**RE: Albuquerque RV & Boat Storage
2201 Vista Oriente St. NW
Grading and Drainage Plan
Engineer's Stamp Date: 05/20/19
Hydrology File: H09D030**

Based upon the information provided in your submittal received 05/20/19, the Grading and Drainage Plan **is not** approved for Building Permit and SO19 Permit. The following comments need to be addressed for approval of the above referenced project:

DETAILS & CALCULATIONS

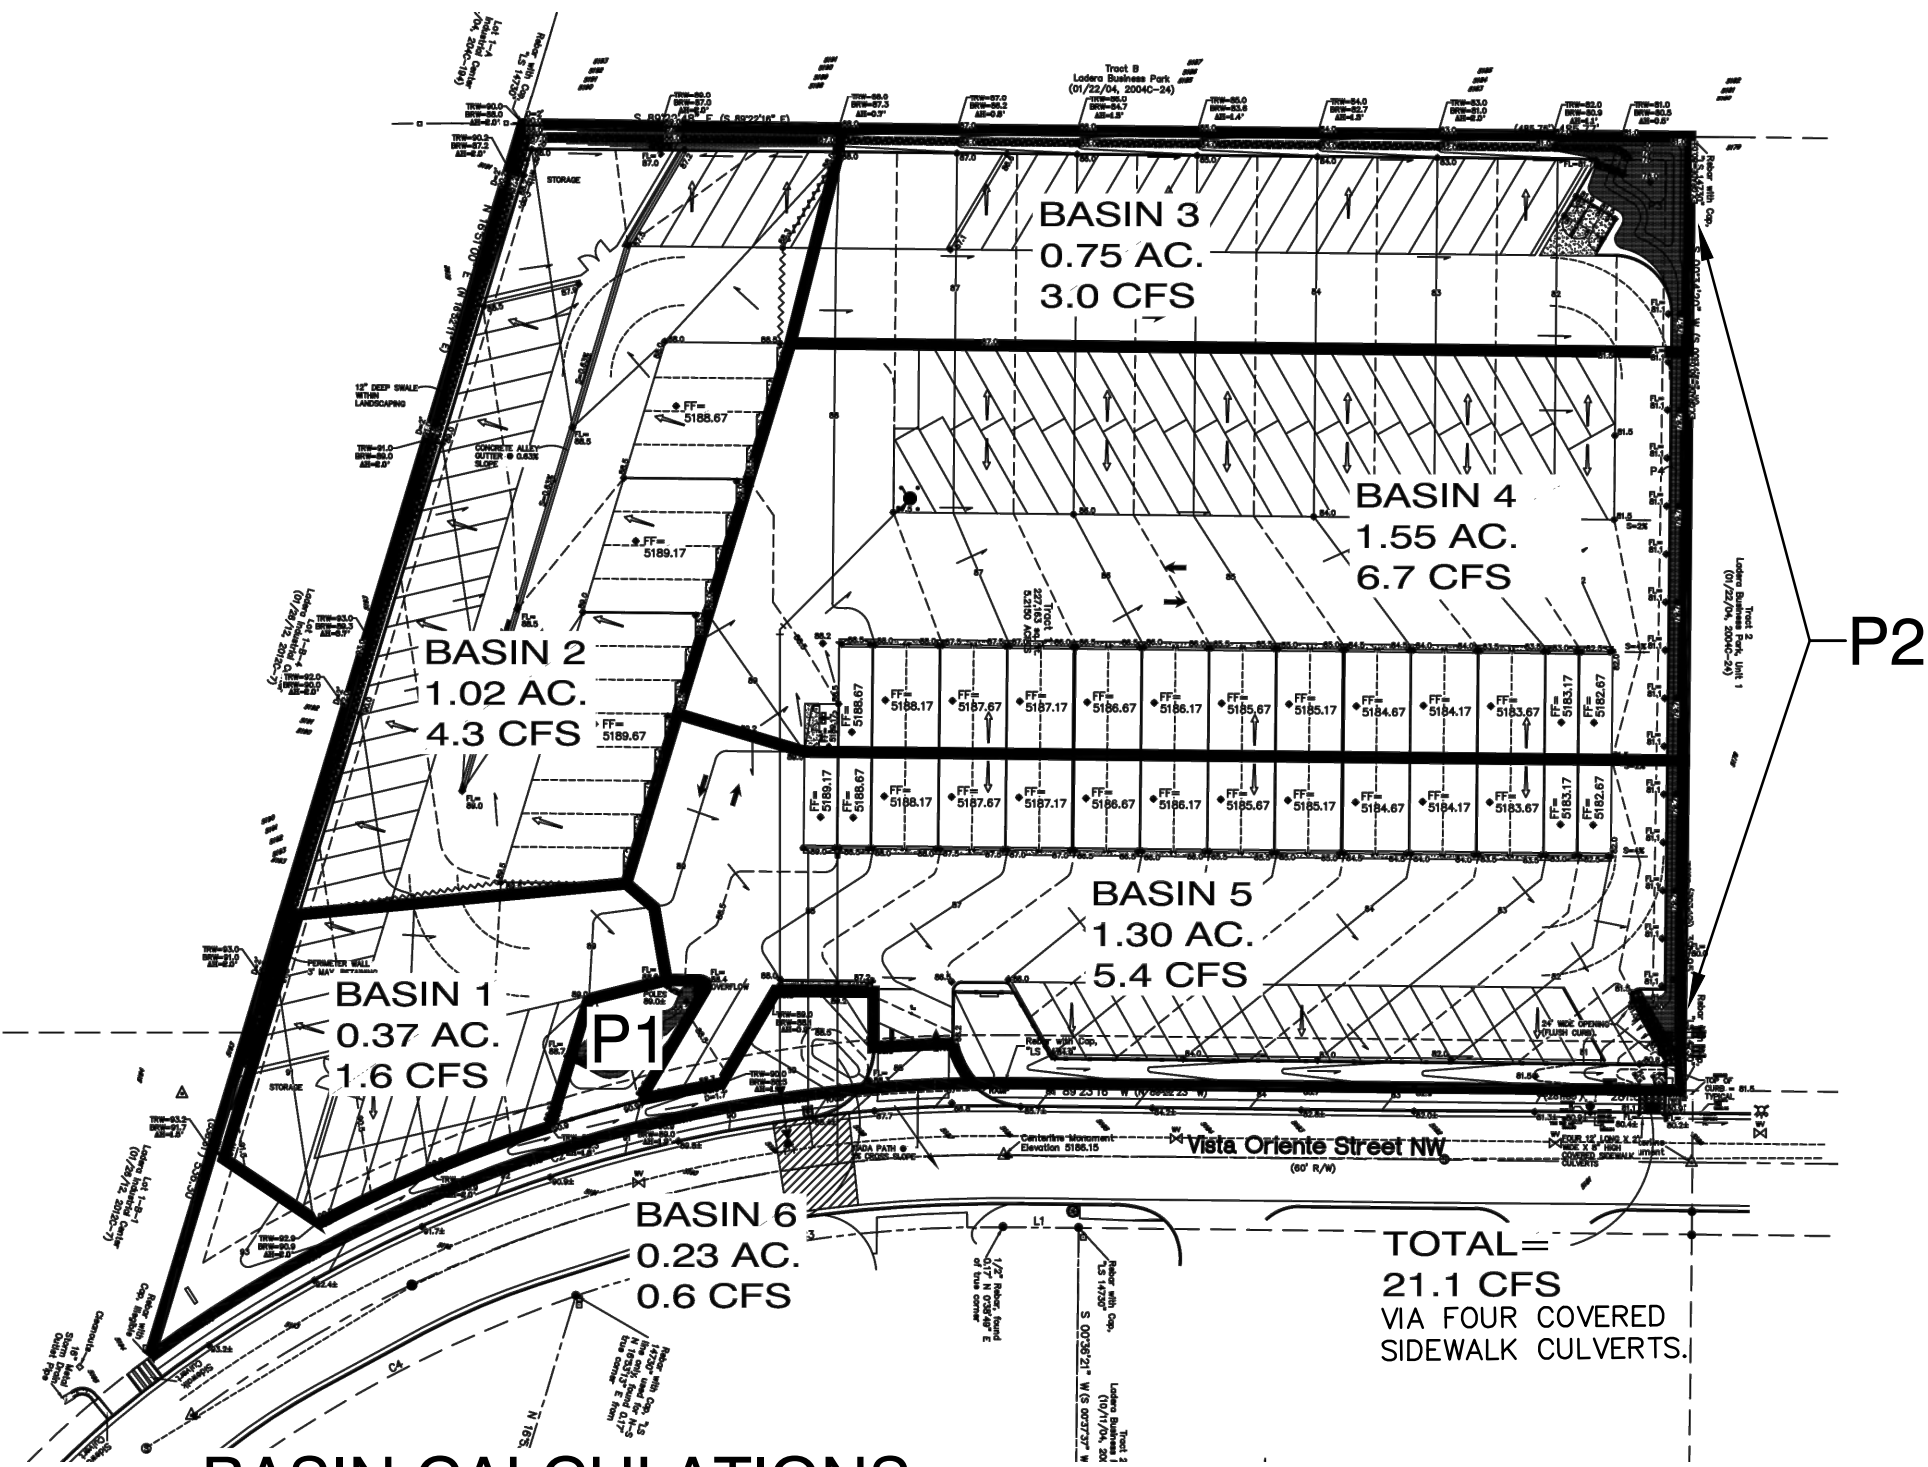
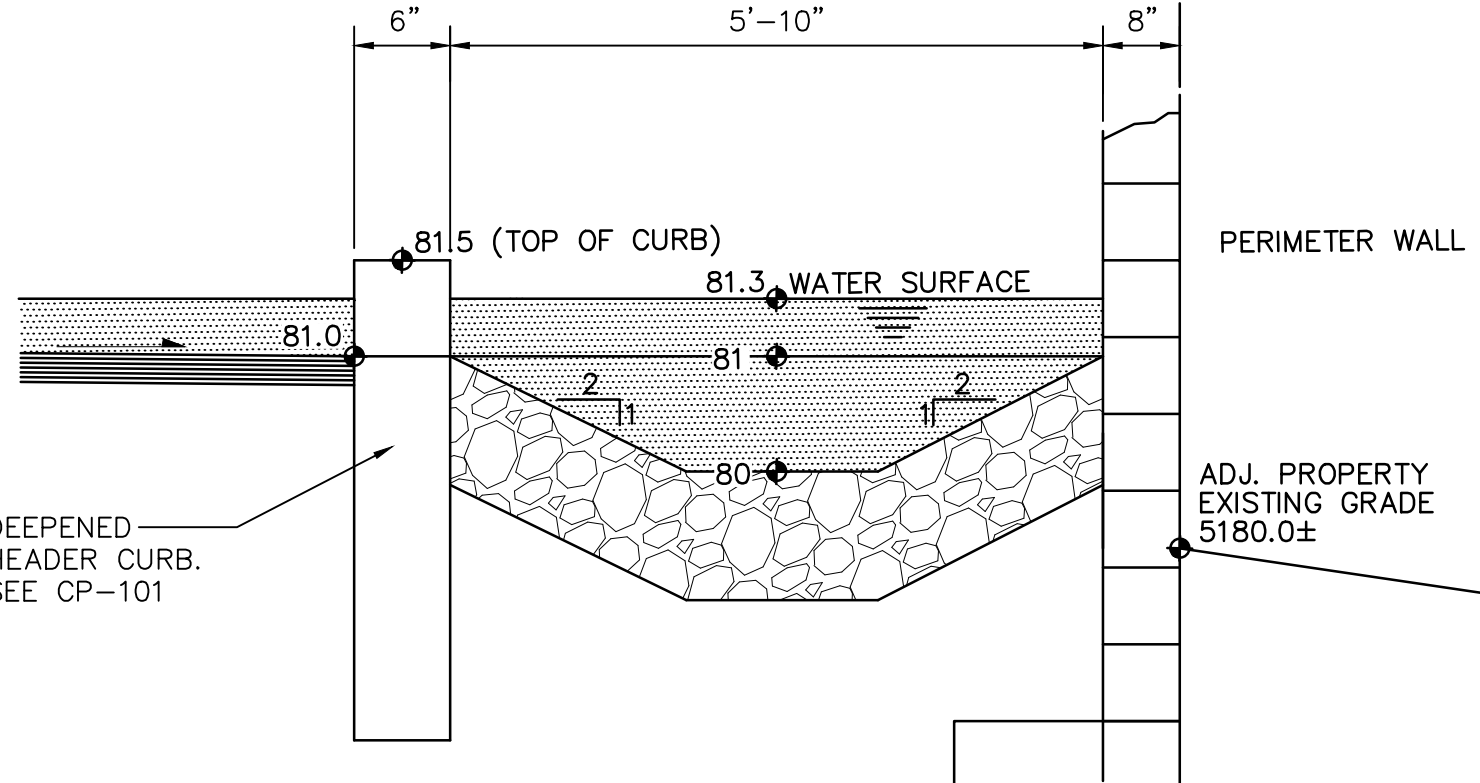
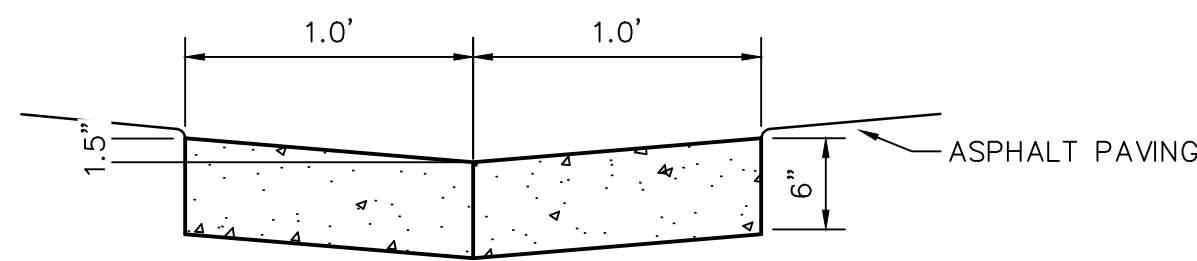
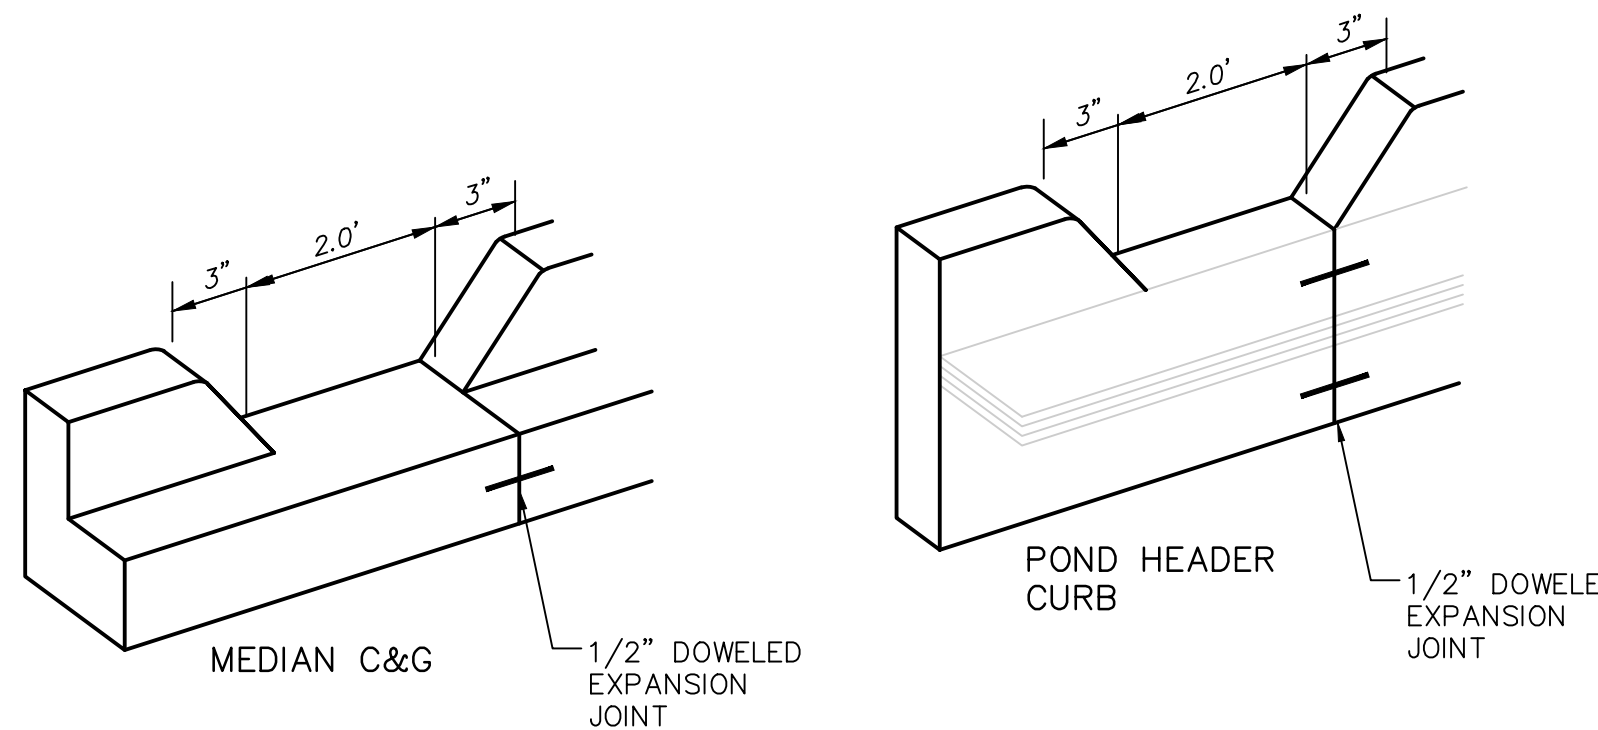
5. For the sidewalk culverts, instead of the orifice equation which was used, the broad crest weir equation ($Q = CLH^{2/3}$) with coefficient "C" =3 for a broad-crested weir must be used, not the orifice equation. Running both formulas reveals that the weir equation is the controlling equation for this application. Per, Handbook of Hydraulics, Brater and King, 6th Edition (1976), Table 5-5(a), a C coefficient of 3.06 is the most appropriate value, but anything in the 2.95 to 3.09 range would be reasonable. Even if the orifice equation governed, this application of the orifice equation erroneously uses h ranging from 0.74'

to 0.89'; per the DPM Ch.22, section 3, part A: h = Depth of water measured from the center of the opening, so h should be 0.292'. So if you use the weir equation, $Q = 4.19$ cfs per sidewalk culvert. If you use the orifice equation with the correct height, $Q = 3.23$ cfs per sidewalk culvert. So the site has a flow of 20.4 cfs, so you would need 5 – 2 ft sidewalk culverts. Please correct.

6. Please add the weir equation for the 28' emergency overflow spillway.
7. As a reminder, if the project total area of disturbance (including the staging area and any work within the adjacent Right-of-Way) is 1 acre or more, then an Erosion and Sediment Control (ESC) Plan and Owner's certified Notice of Intent (NOI) is required to be submitted to the Stormwater Quality Engineer (Curtis Cherne, PE, ccherne@cabq.gov, 924-3420) 14 days prior to any earth disturbance.
8. As a reminder, please provide a Drainage Covenant per Chapter 17 of the DPM for water quality ponds prior to Permanent Release of Occupancy. Please submit this on the 4th floor of Plaza de Sol. A \$25 fee will be required.
9. Standard review fee of \$150 will be required at the time of resubmittal.
